# **PRELIMINARY/FINAL DRAINAGE REPORT**

## **APPALOOSA HWY 24 SUBDIVISION FILING NO. 1A, LOTS 1, 2 & 3**

**ADP Project No. 160504  
December 12, 2018**

### Routed Hydrograph Results

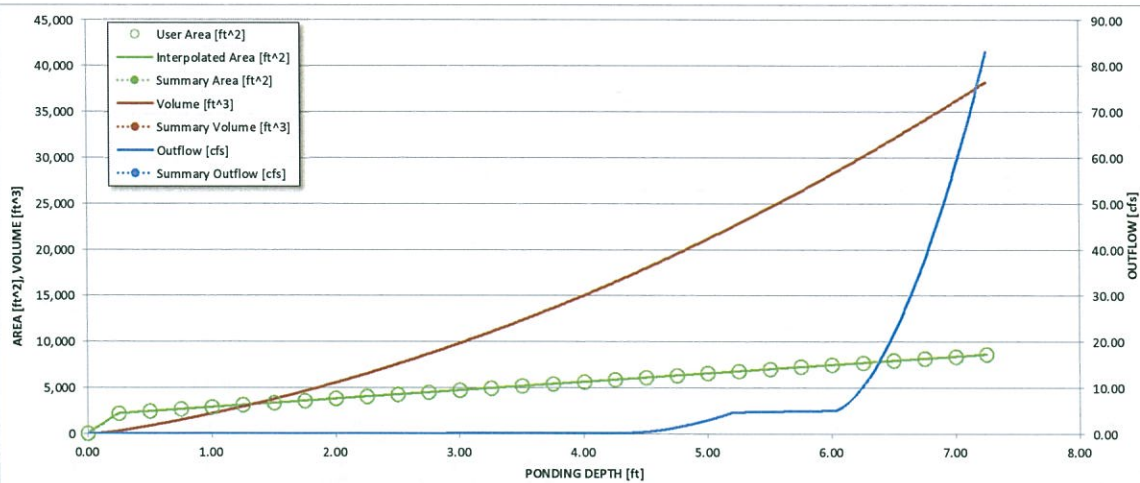
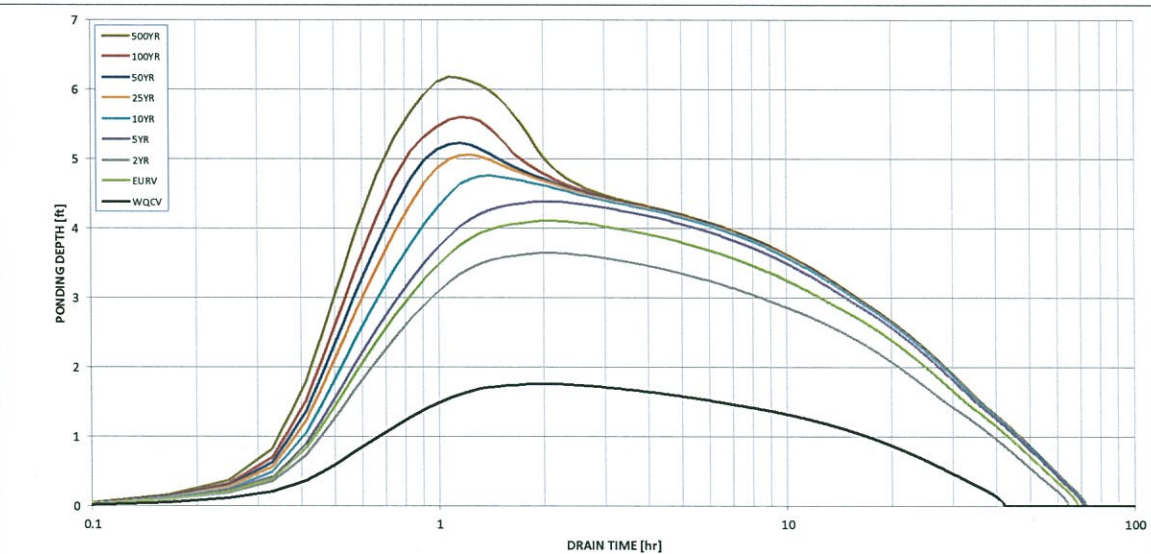
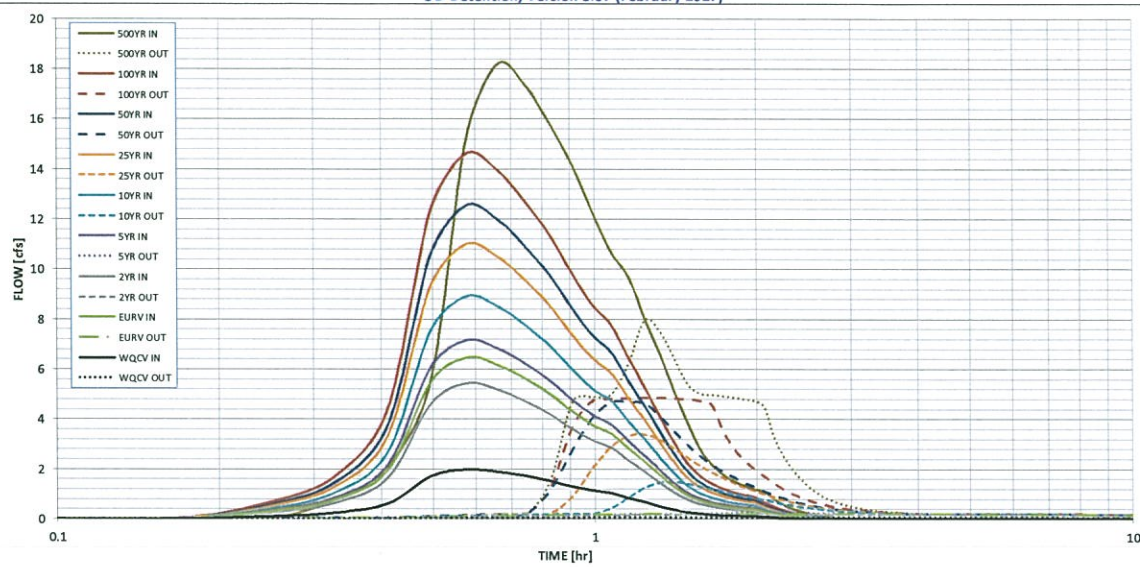
Must release at or below the predeveloped rate. Revise.
